**COUNTY OF VENTURA
PUBLIC WORKS AGENCY**

Addendum No.1

Subject: **Project Name: Newbury Park Drain No. 1 Downstream of Michael Drive**
Specification No. WP21-07; Project No. 86140
Bids to be Opened August 10, 2021

NEWBURY PARK DRAIN NO. 1 DOWNSTREAM OF MICHAEL DRIVE PLAN AND PROFILE

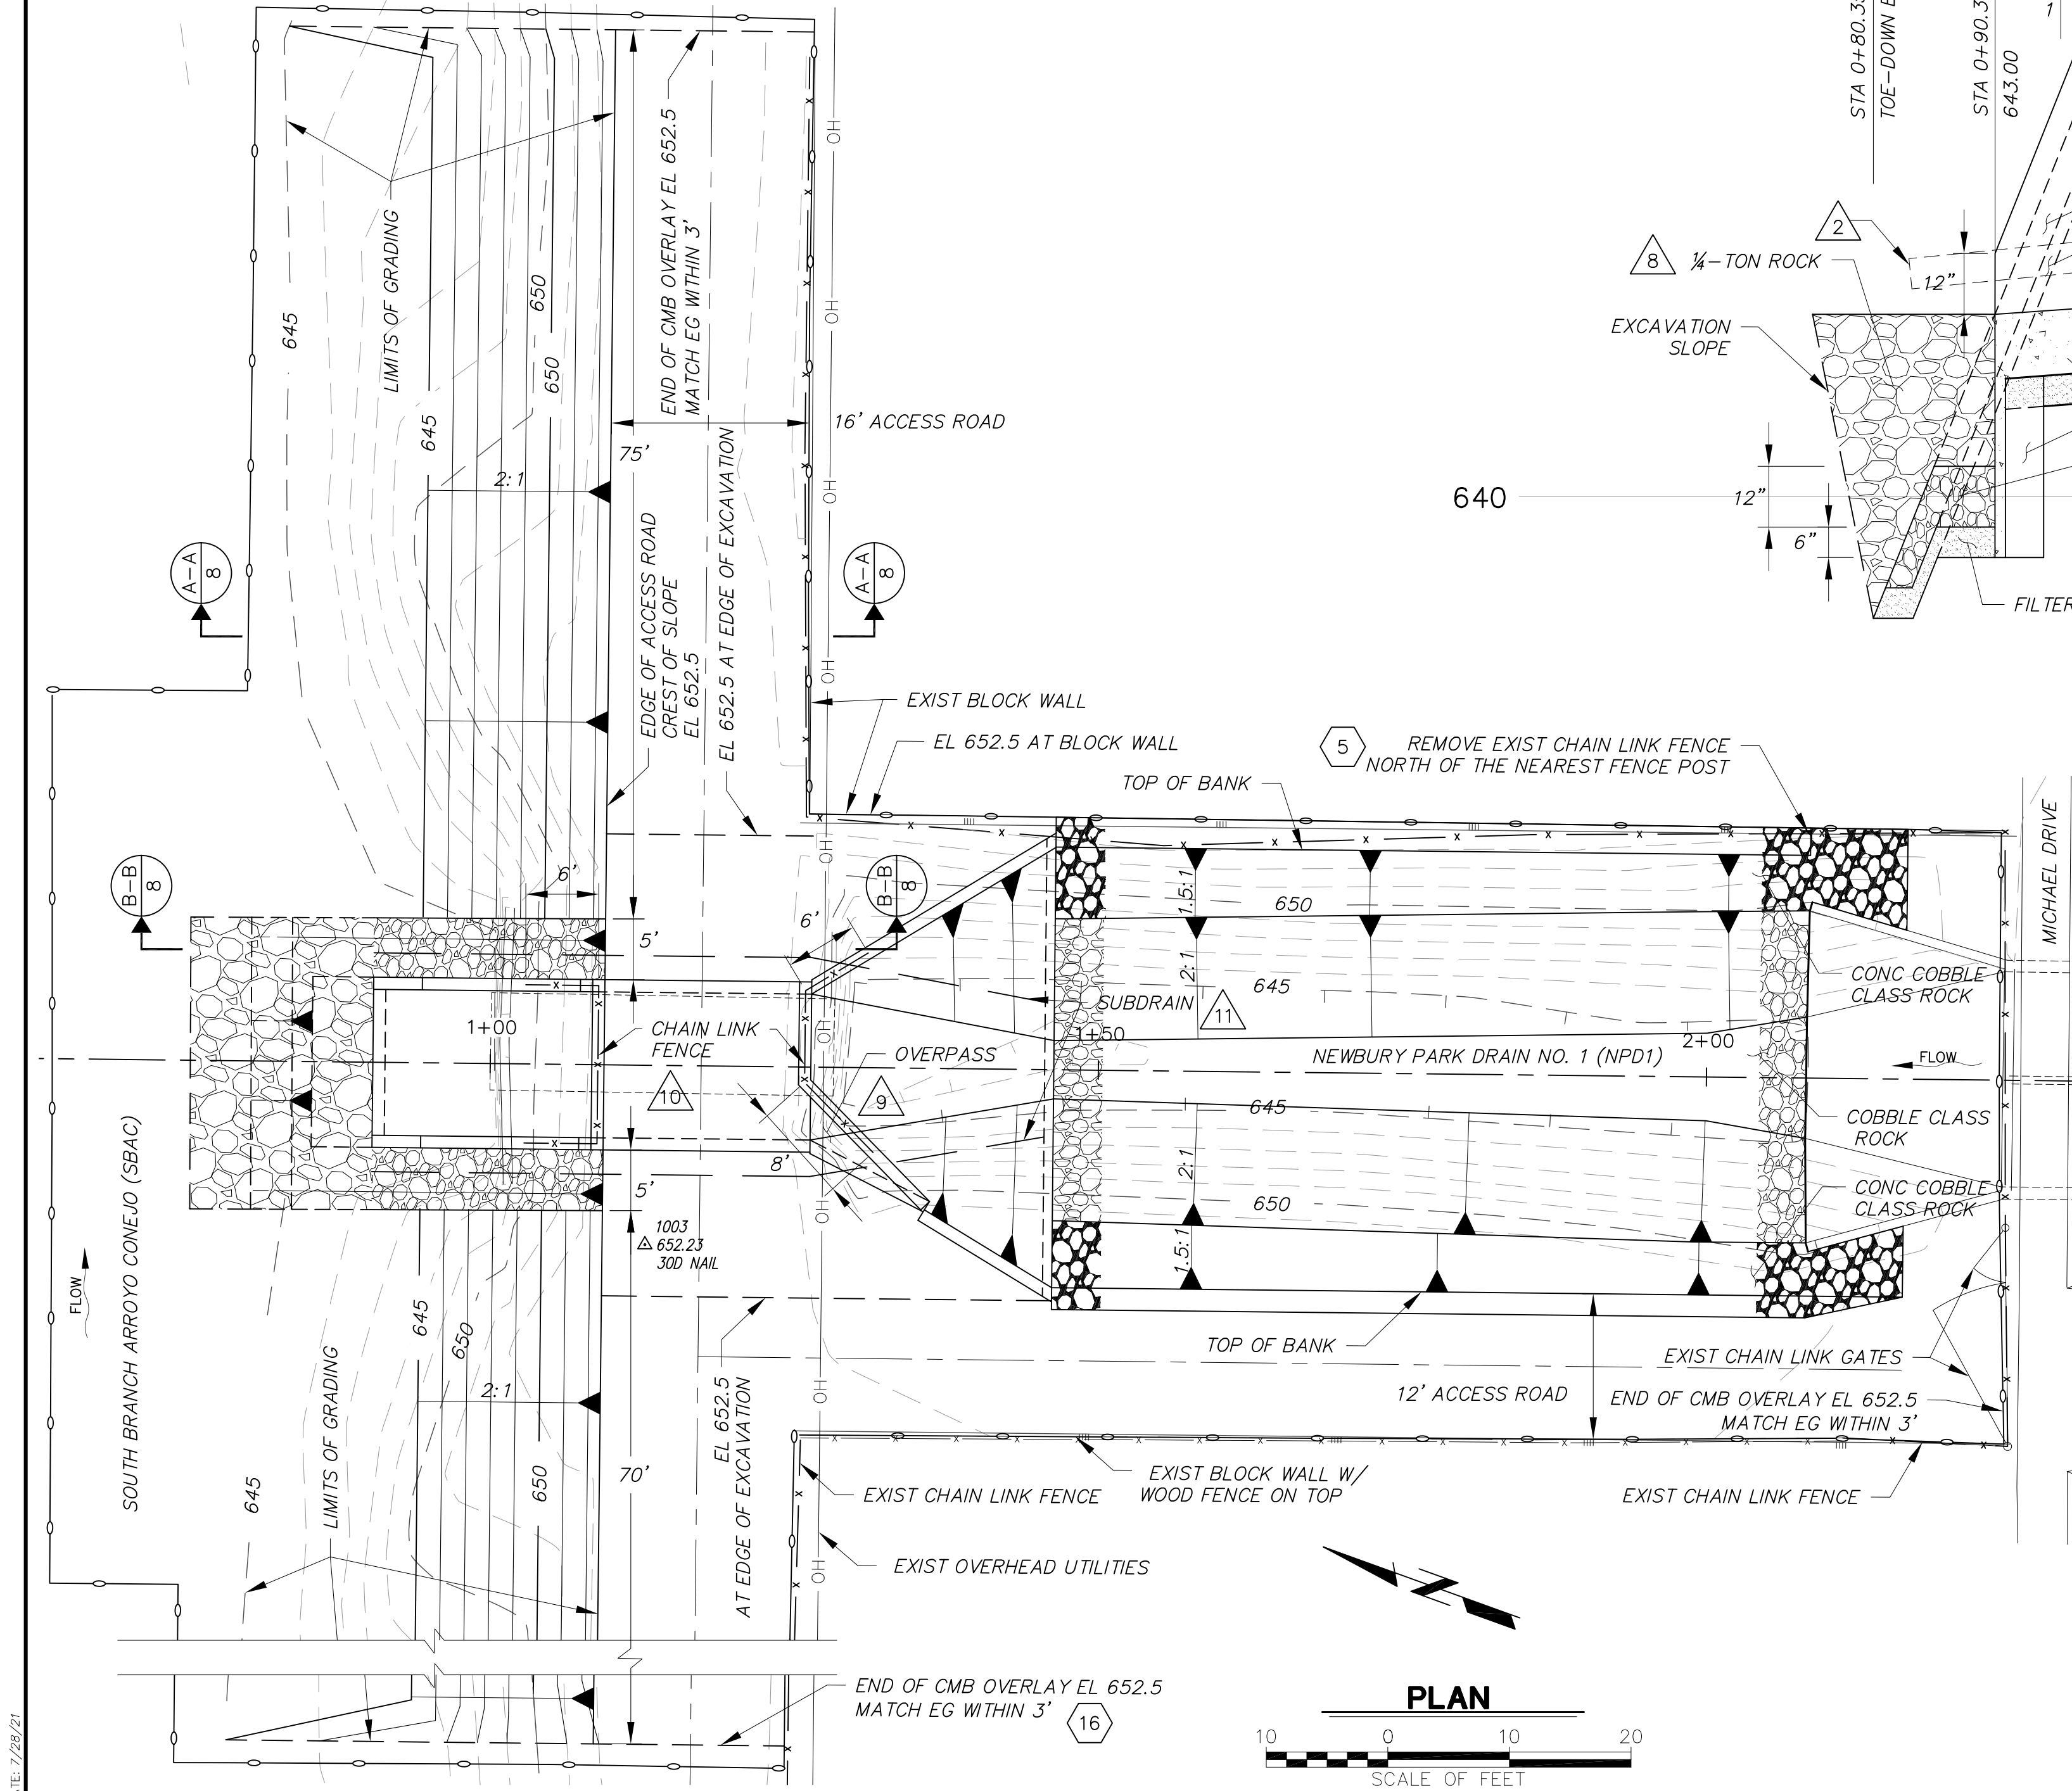
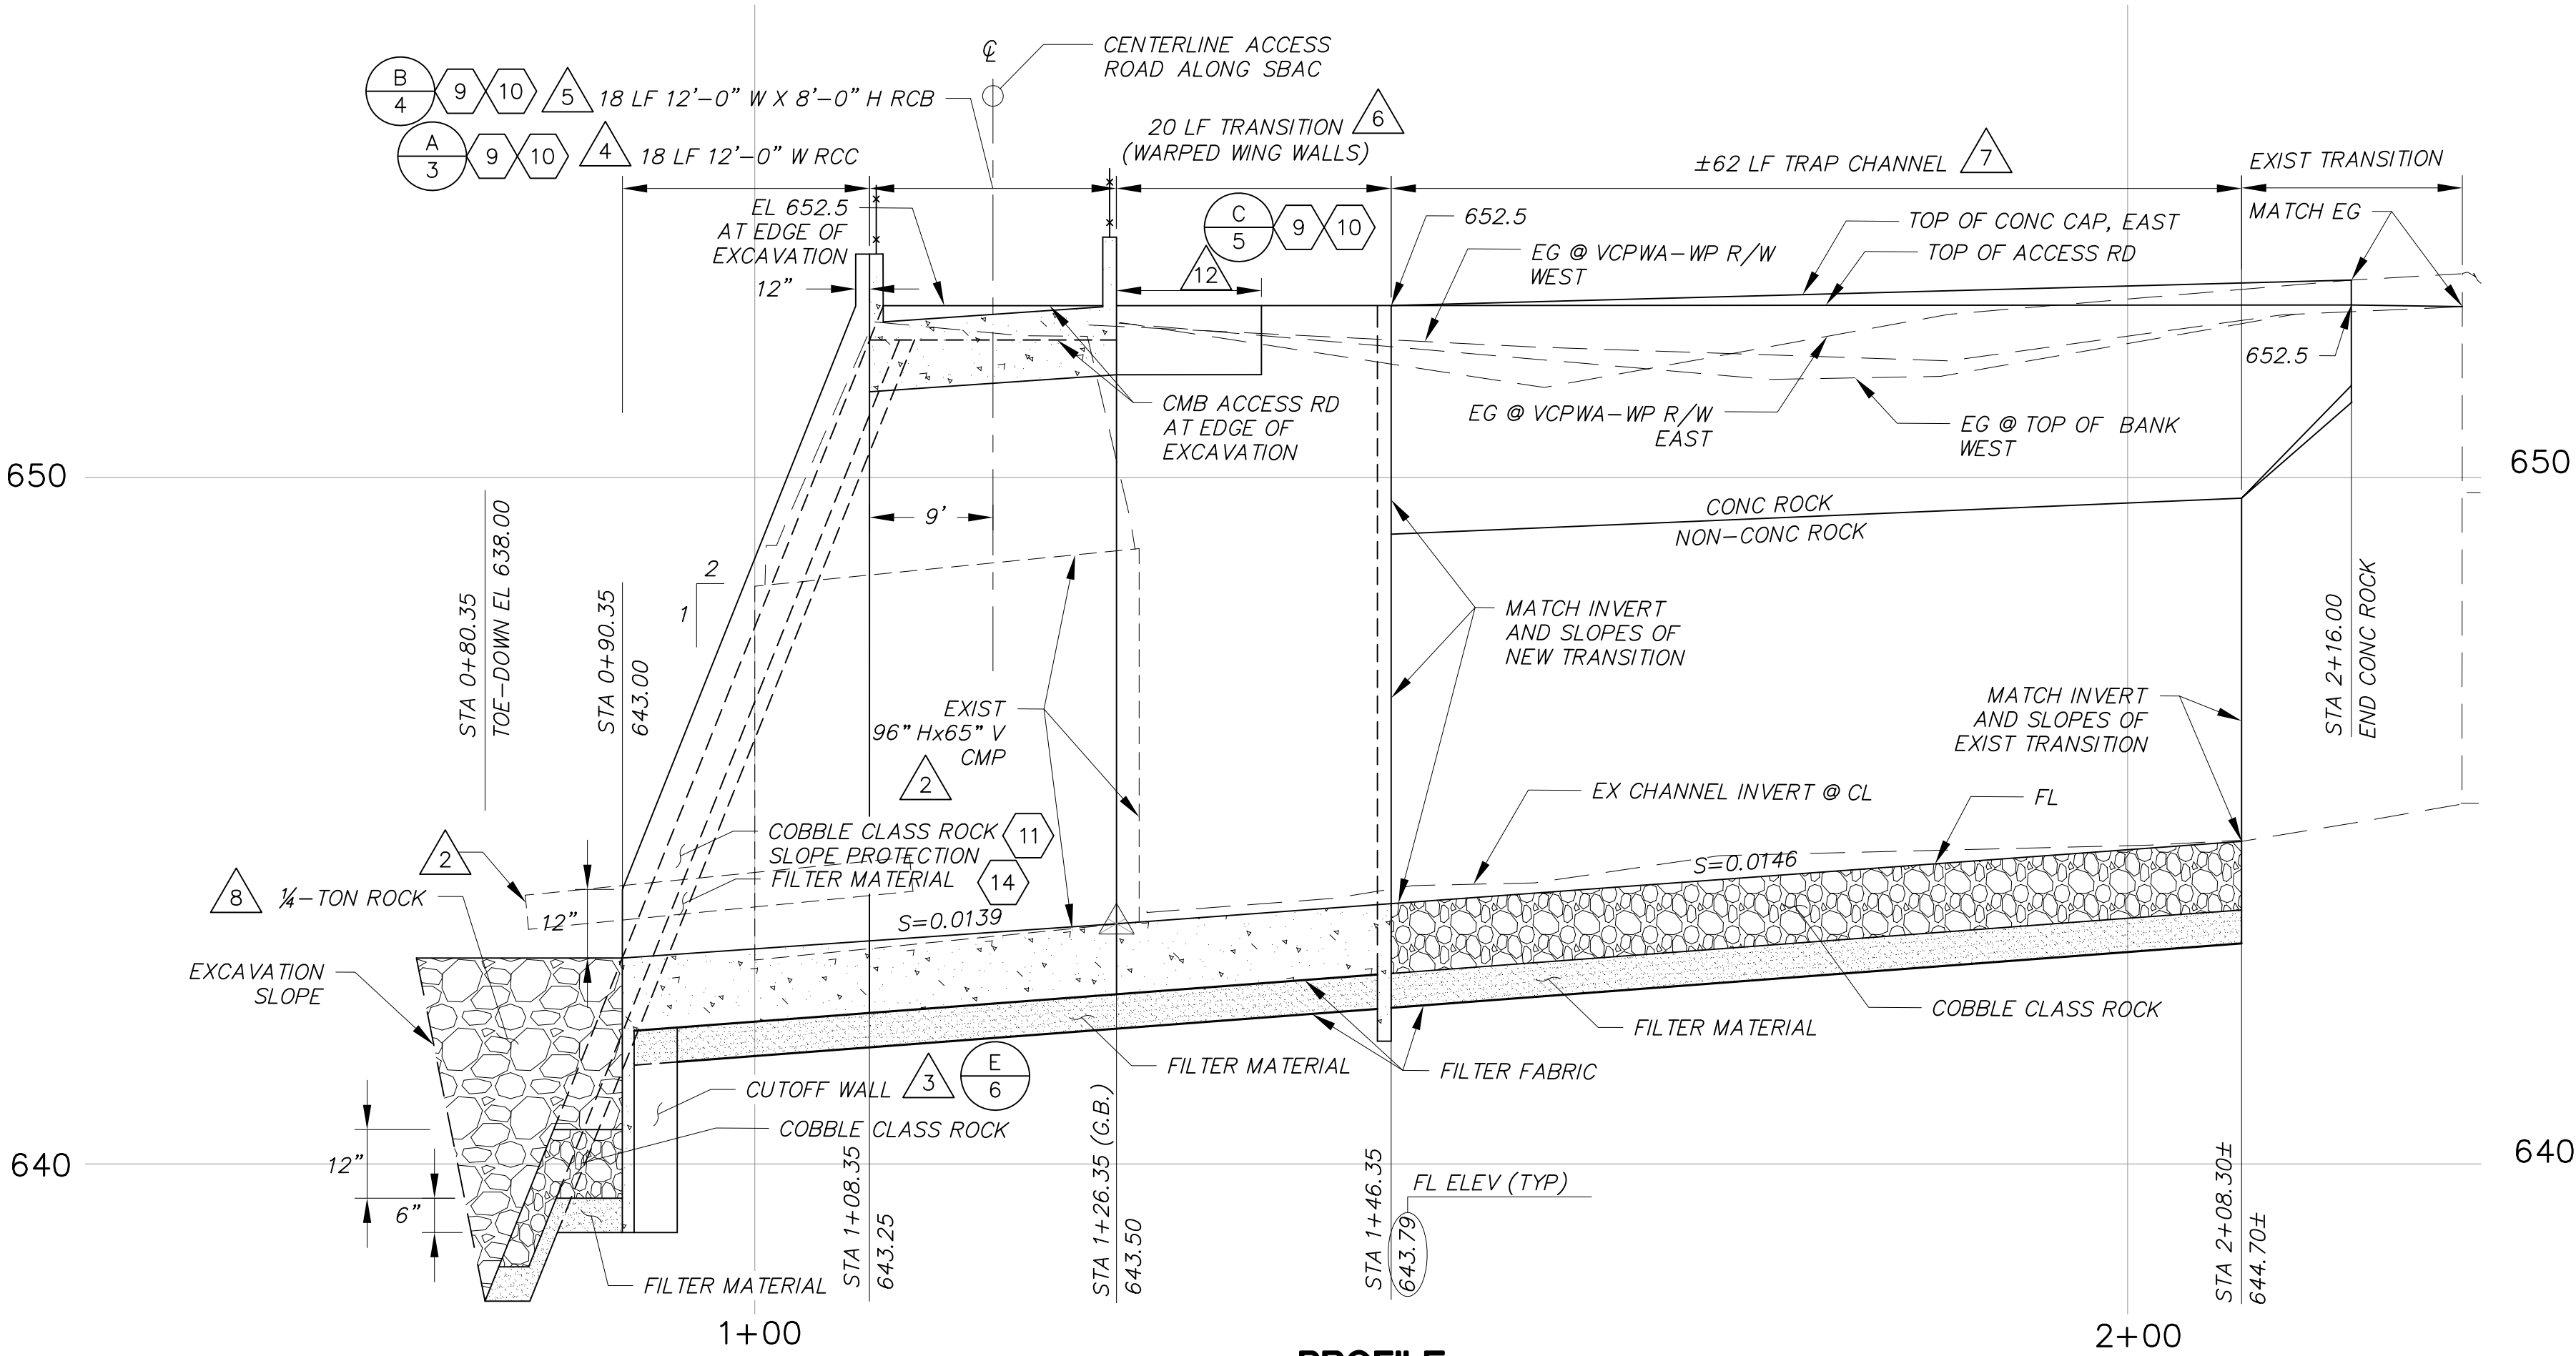
1. Replace Sheet 2, PLAN AND PROFILE, of the Plans with the attached, revised Sheet 2, dated 8/2/2021 revisions include added Survey Control, show existing contours, and revise the linework for the Overpass.

OVERPASS DETAIL
NOT TO SCALE

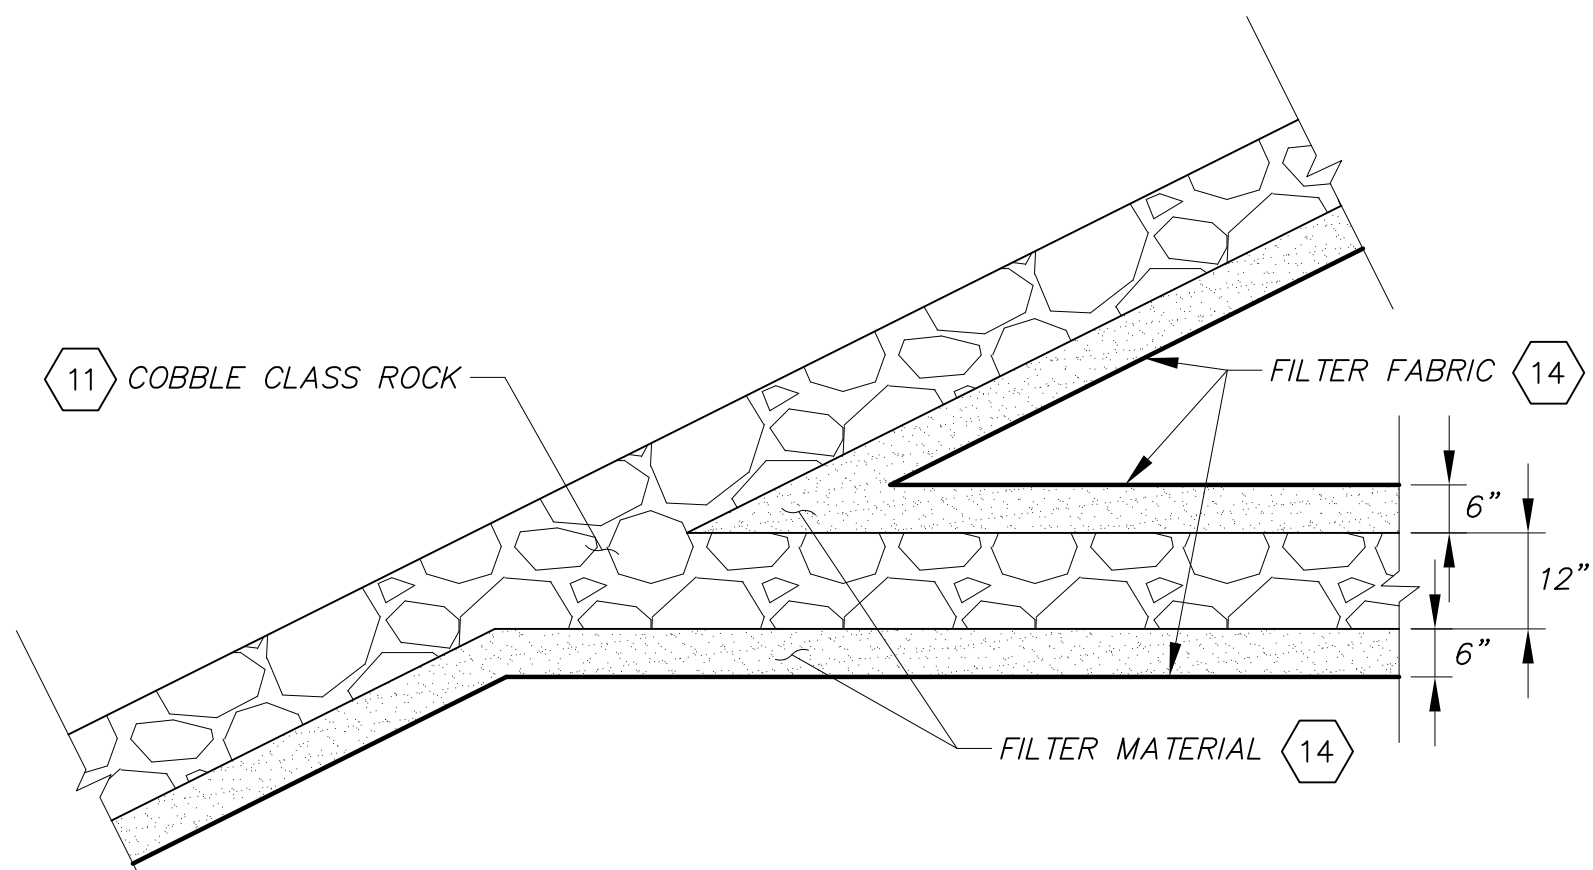
2. Replace Sheet 6, MISCELLANEOUS DETAILS, of the Plans with the attached, revised Sheet 6, dated 8/2/2021 revision include linework for the Overpass Detail.
